Rear Shelf Speaker Aperture Modification

Background

Early Nissan Bluebird

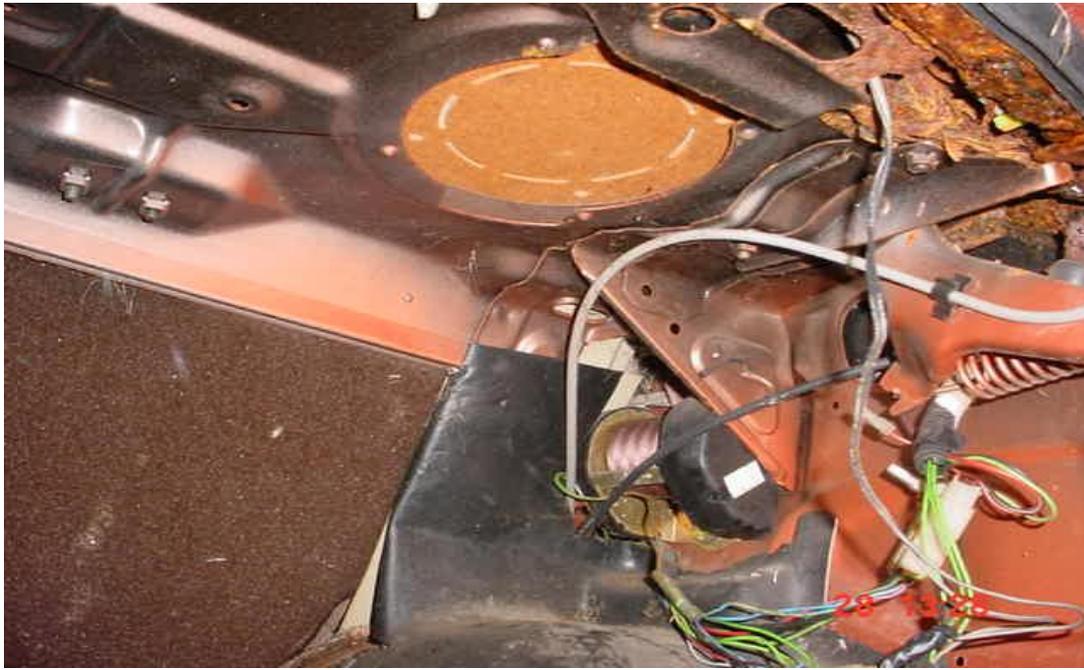
This Nissan Bluebird static anchorage would pull forwards on the C-pillar and inwards during an impact. The sheet metal structure forming the rear of the seat would still provide support to the C-pillar's inward loading, even if the rear shelf speaker aperture were to be enlarged.
